DELAURENTIS - VACANT LOT - 21 NETHERMONT AVE NEW HOUSE CONSTRUCTION - TAX ID: SECTION 122.16-BLOCK 4- LOT 41

Re: 21 Nethermont Ave - Section, Block & Lot: 122.16/4/41 – Response to RPRC Determination Letter

After attending a meeting with the RPRC, we have been referred to the Planning Board to discuss the subject project further. Below are responses to the questions/comments from the RPRC Determination Letter dated 10/06/2020:

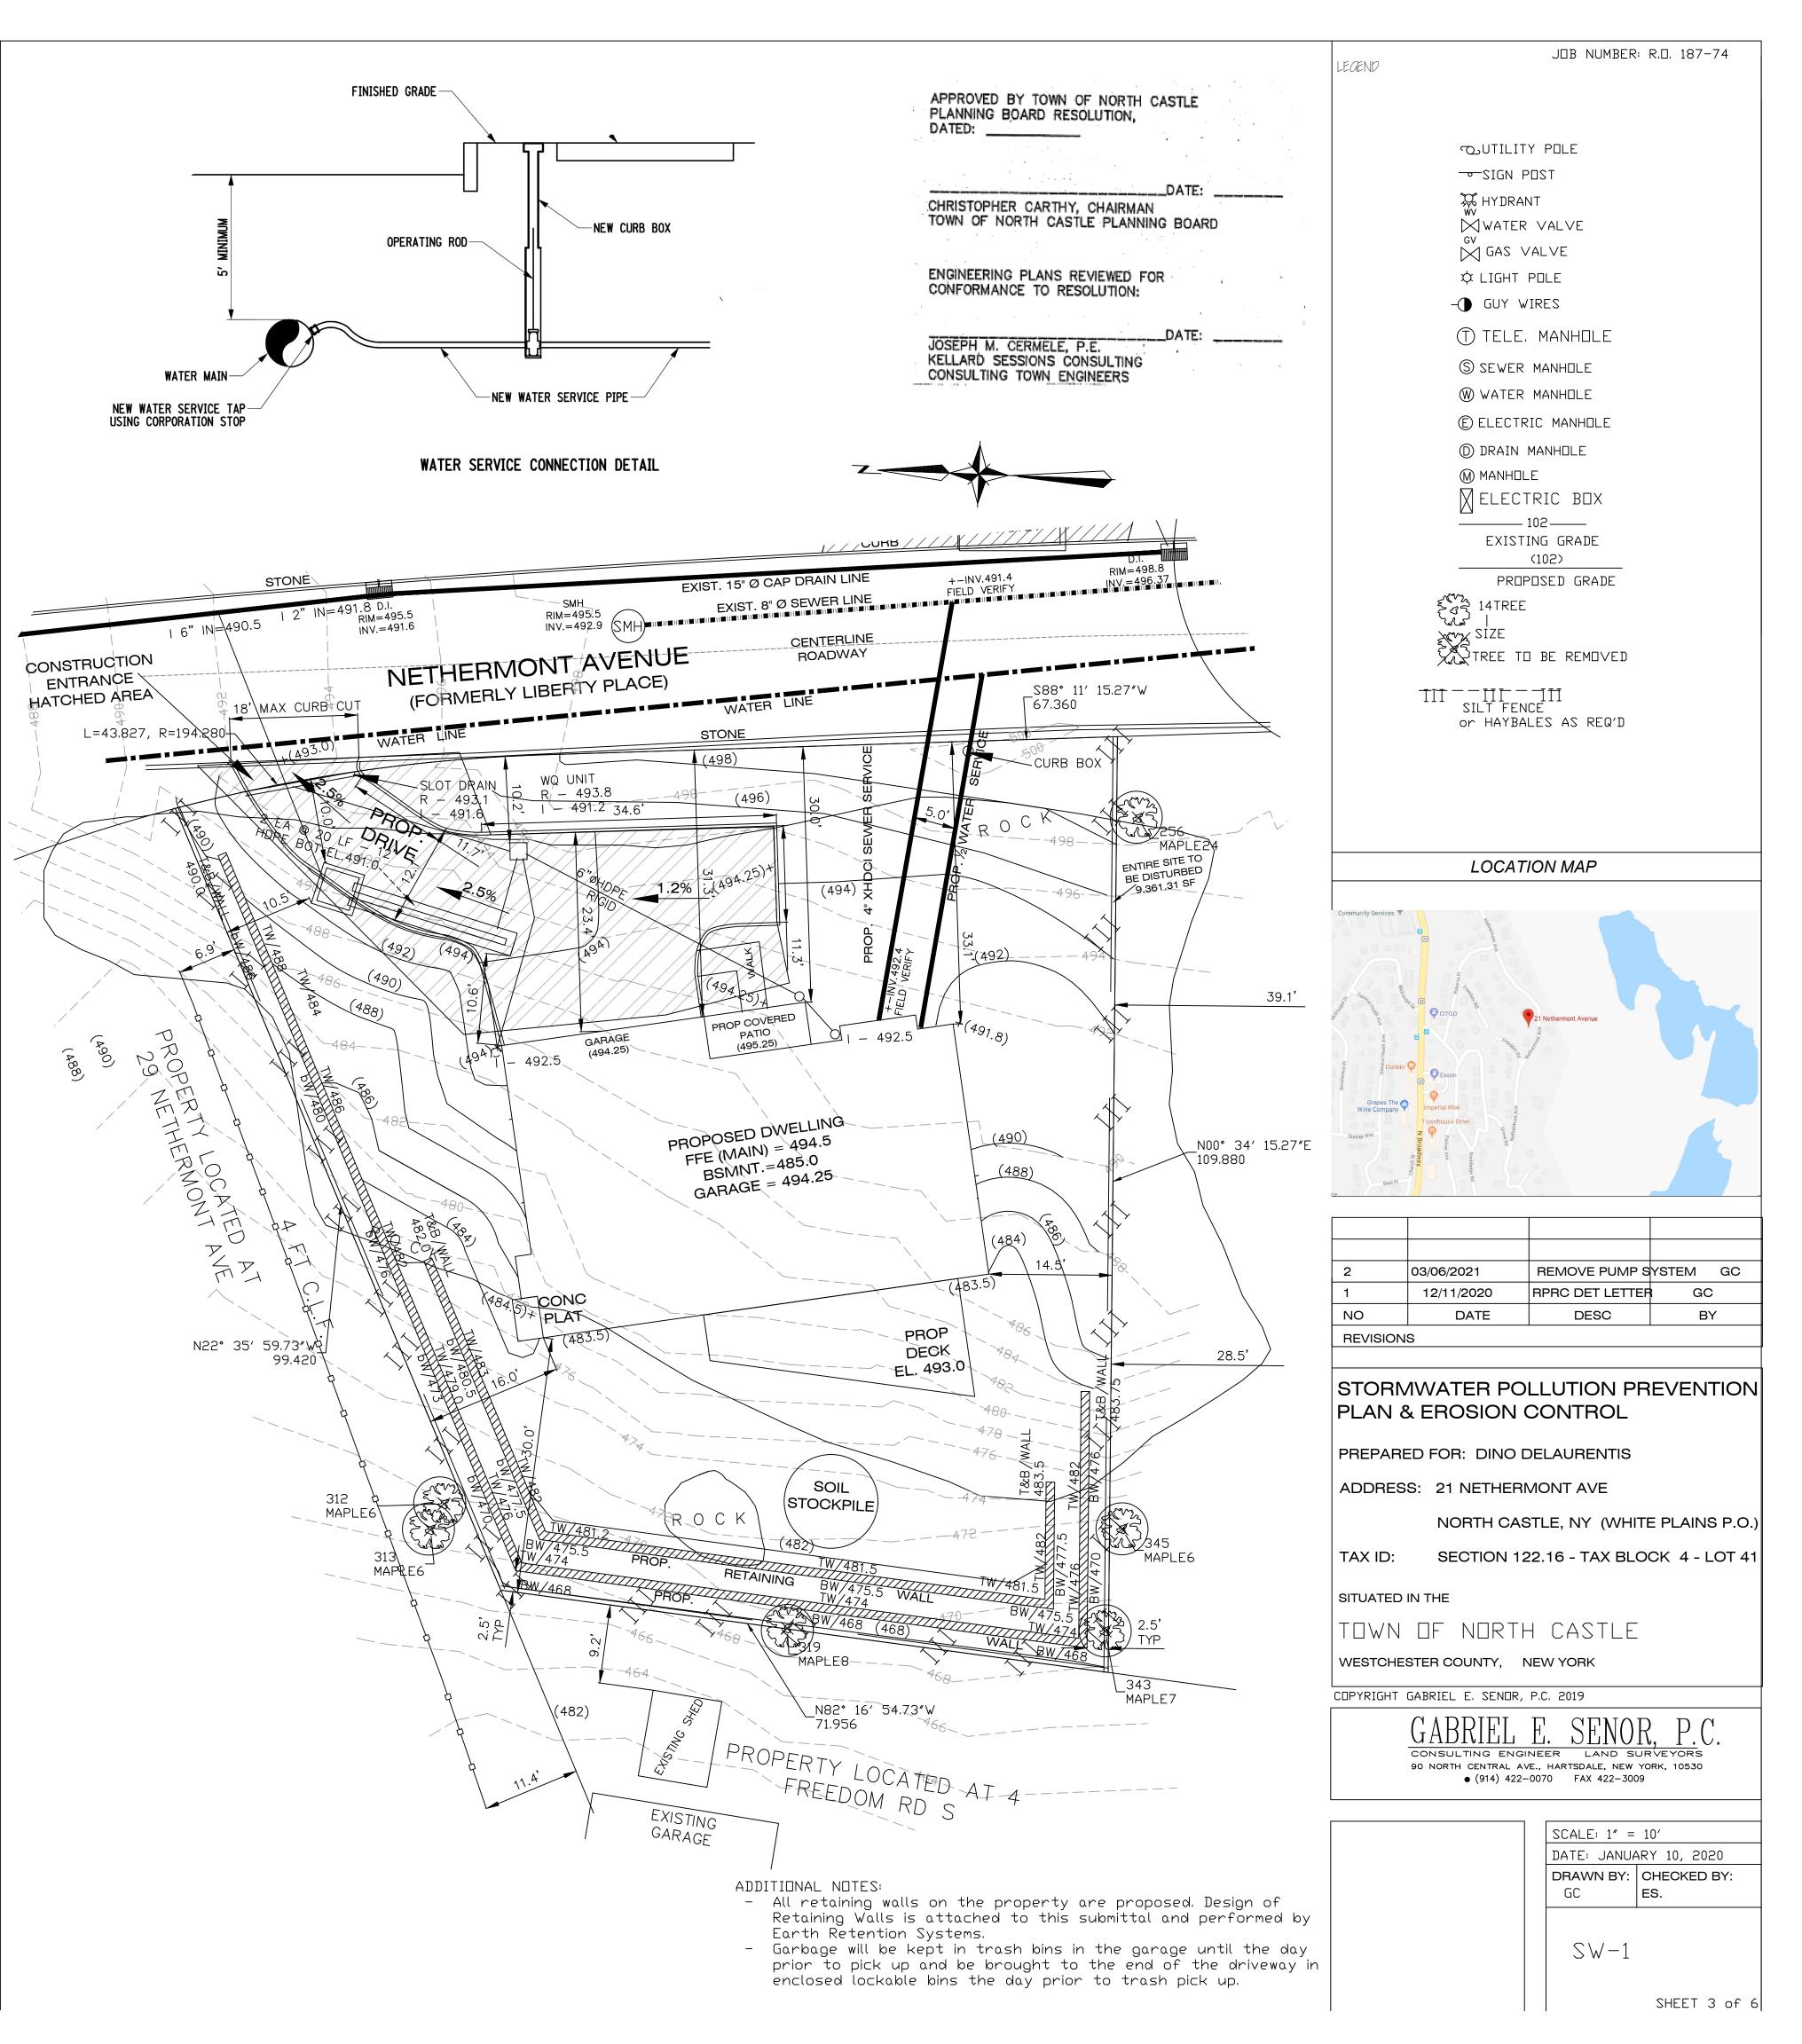
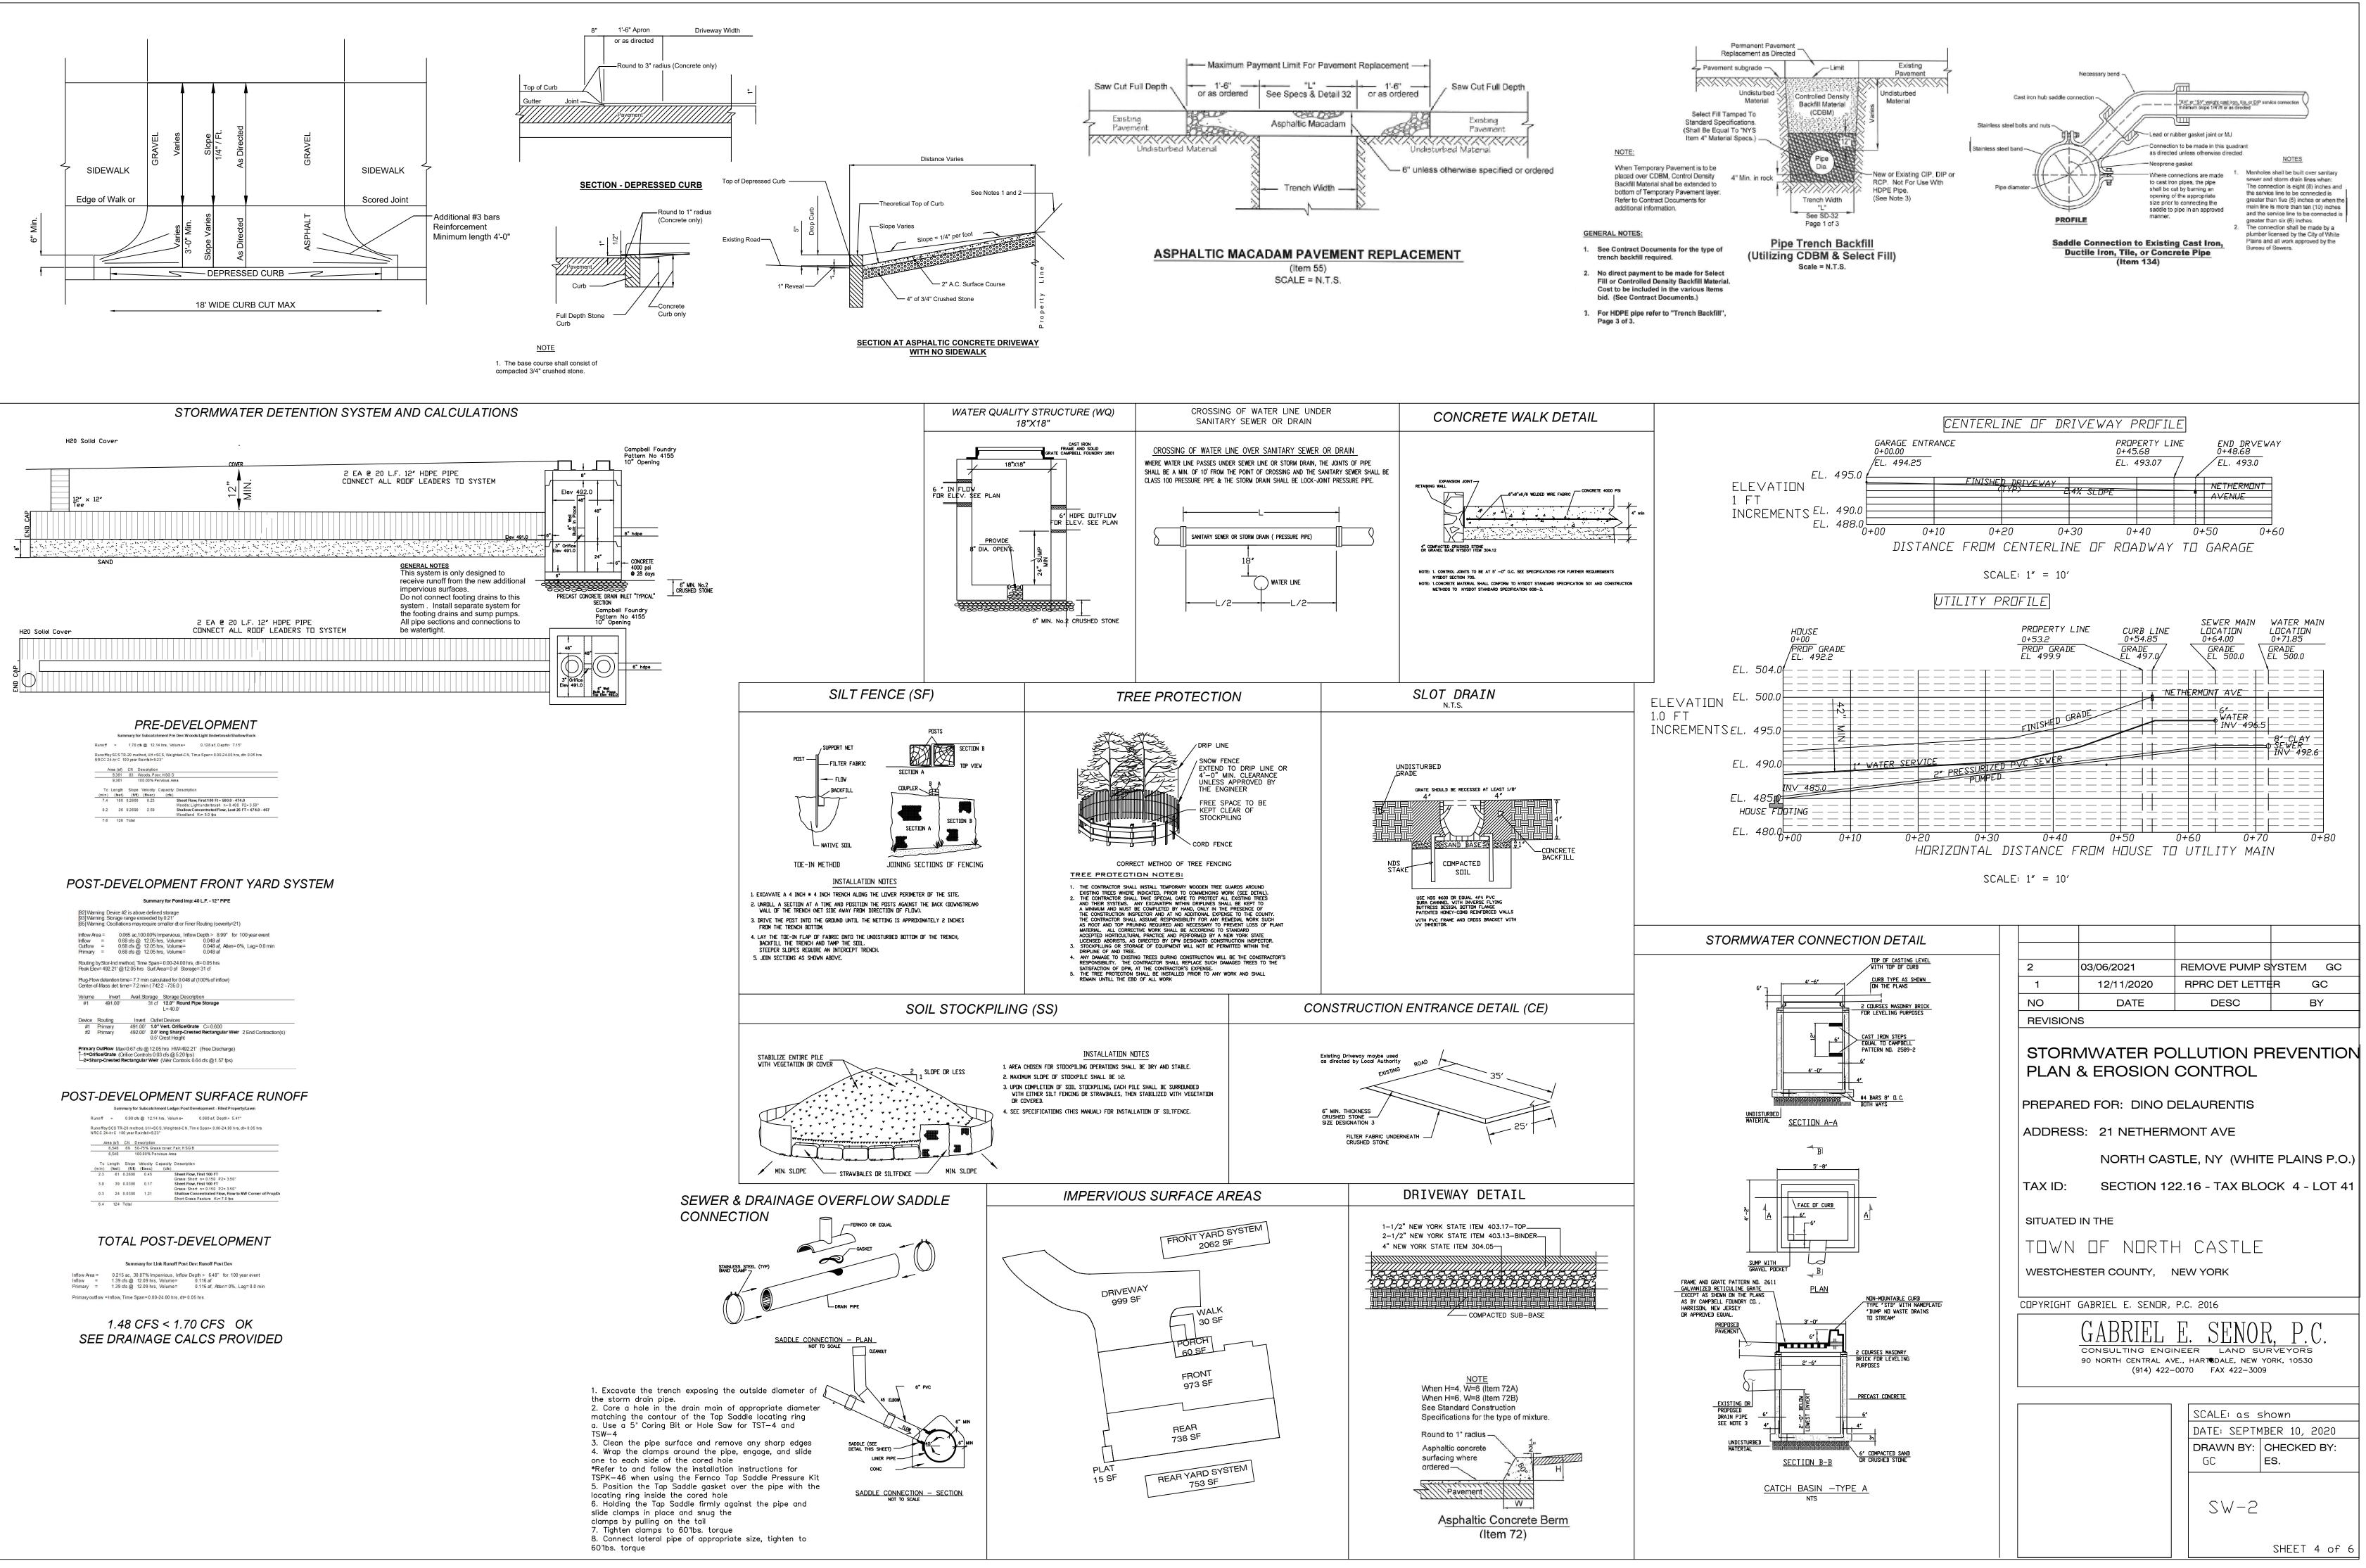
- The submitted planting plan should be revised to include a plant schedule that includes the common name, scientific name, label, size and quantity of all proposed plants.

- See Landscape Architect Plan Package **Planting Plan** by Walter G. Nestler P.C. Dated 10/10/2020.
- It is noted that the proposed rear retaining walls are located directly on the property line. This configuration creates a significant adverse visual impact to the adjoining property. The retaining walls should be relocated so that screening plantings can be installed at the base of the wall in an effort to mitigate visual impacts.

- The wall has been relocated and screening has been proposed on the low side of the wall. See GABRIEL E SENOR P.C. Site Plan Package **Stormwater Pollution Prevention Plan** Sheet 3 of 6, SW-1 for wall location and see Planting Plan by Landscape Architect for screening.

1 A-400

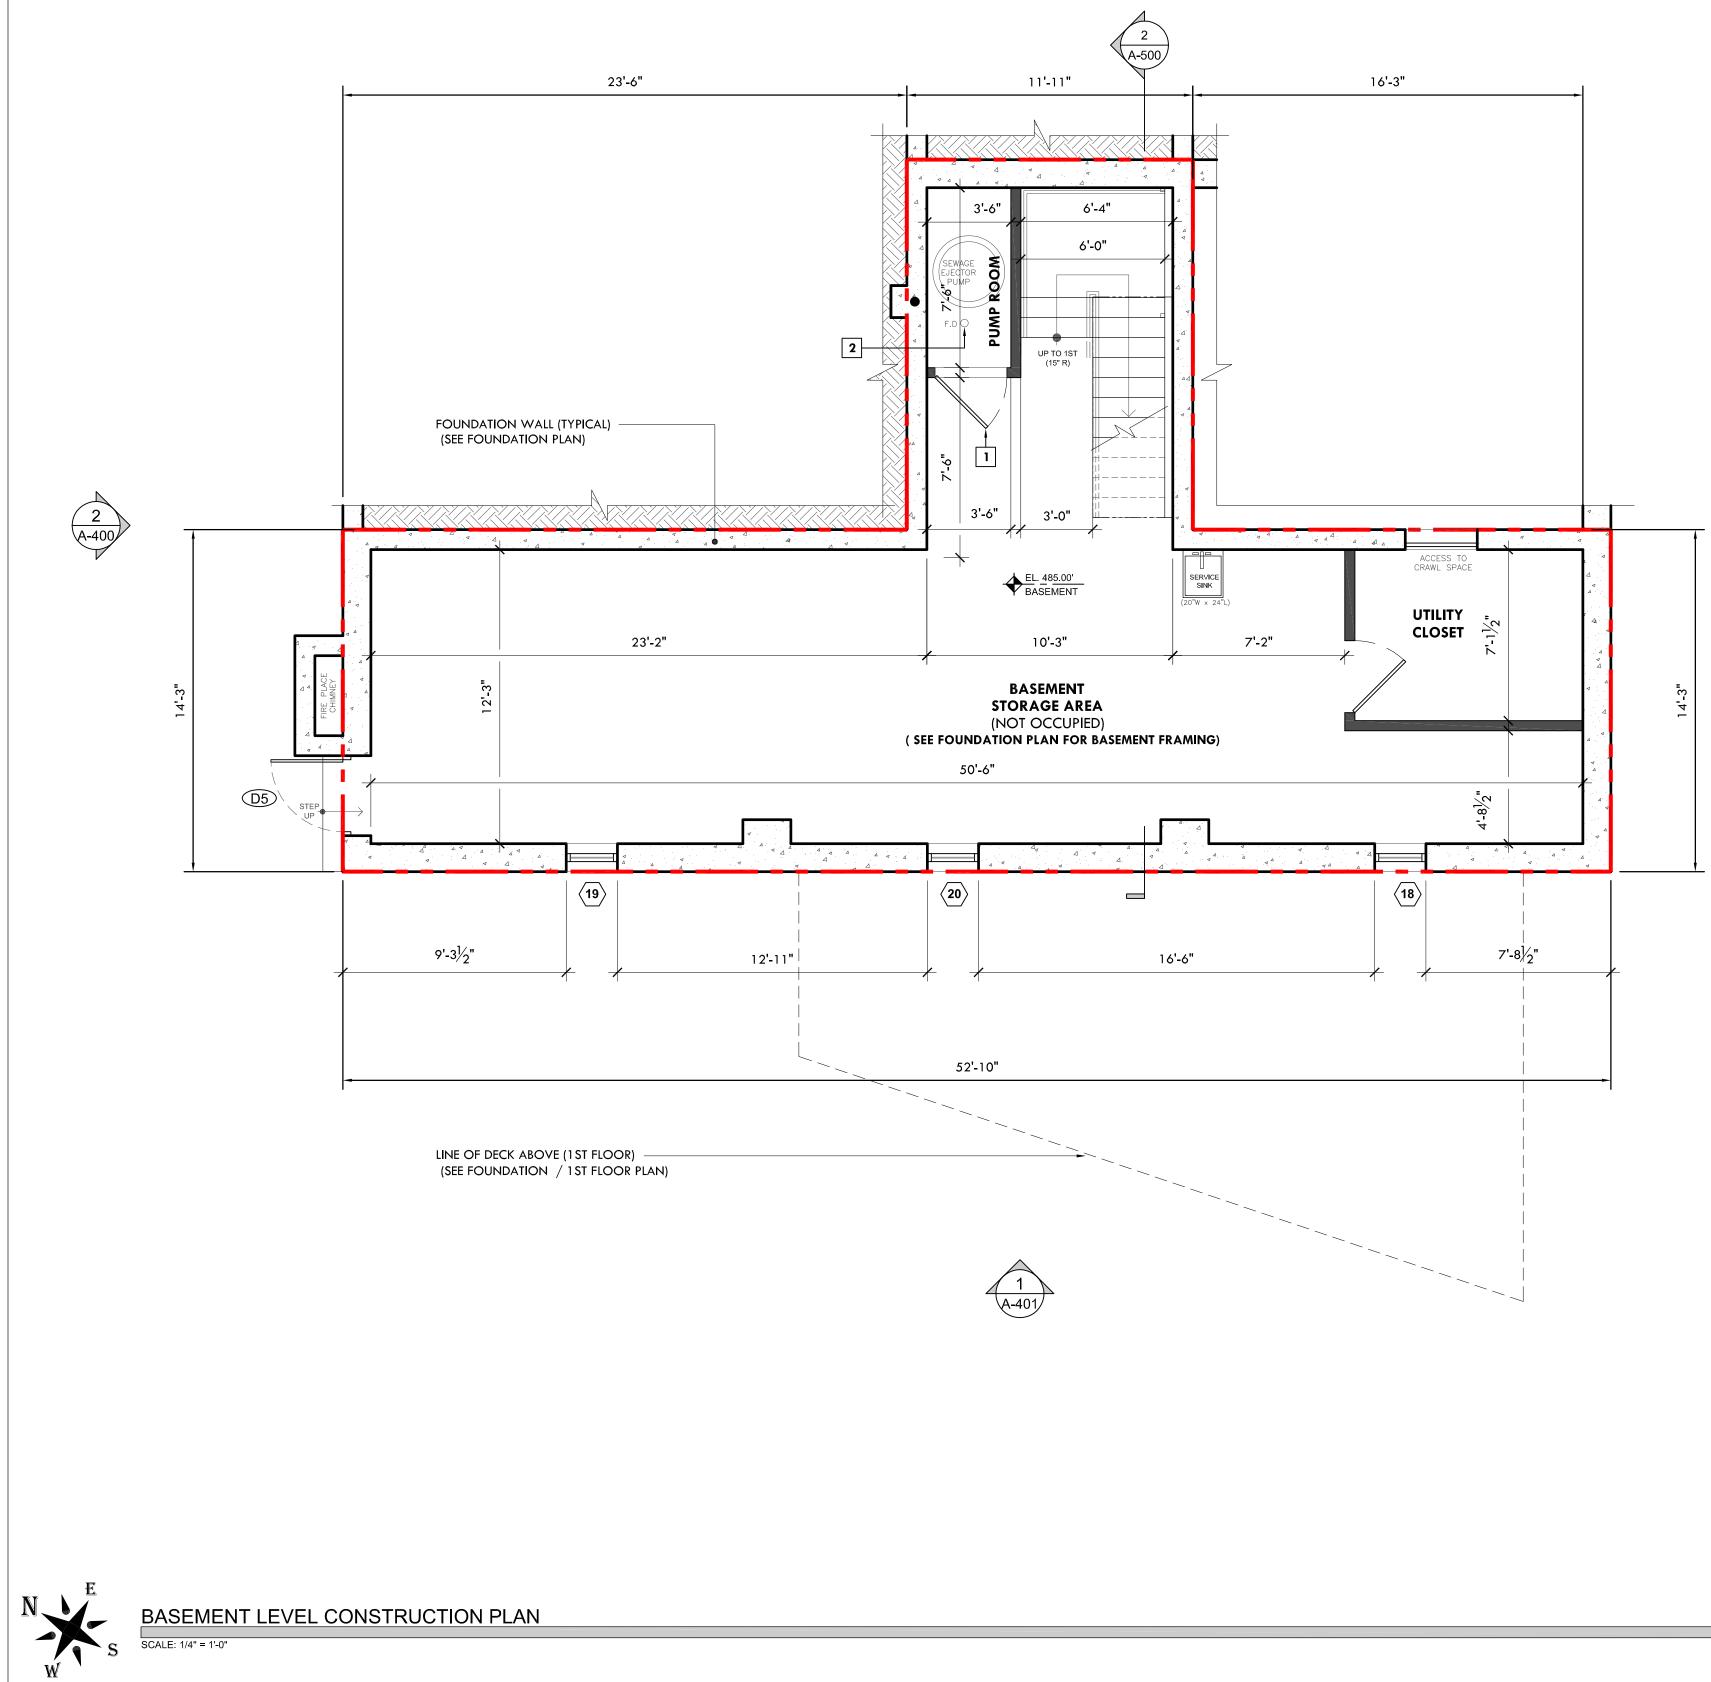
- Provide calculations and exhibits demonstrating how average grade was calculated.
- See GABRIEL E SENOR P.C. Site Plan Package **Stormwater Pollution Prevention Plan** Sheet 3 of 6, SW-1 under the zoning table
- Provide calculations and exhibits demonstrating how roof midpoint was calculated.
- See Architects Plan Package sheets A-400 and A-401 by Taylor Associates Architects, PC
- Given the amount of exposed foundation, the basement may be considered a story. Provide calculations and exhibits demonstrating that basement would not be considered a story. If the basement is a story it must be counted in gross floor area. In addition, if the basement is a story, it would appear that the proposed building would exceed the maximum number of stories (2.5)

Where the finished surface of the floor above the basement is more than six feet above average grade. See Architects Plan Package - sheets A-400 and A-401 by Taylor Associates – Architects, PC

- See Architects Plan Package - sheets A-400 and A-401 by Taylor Associates – Architects, PC
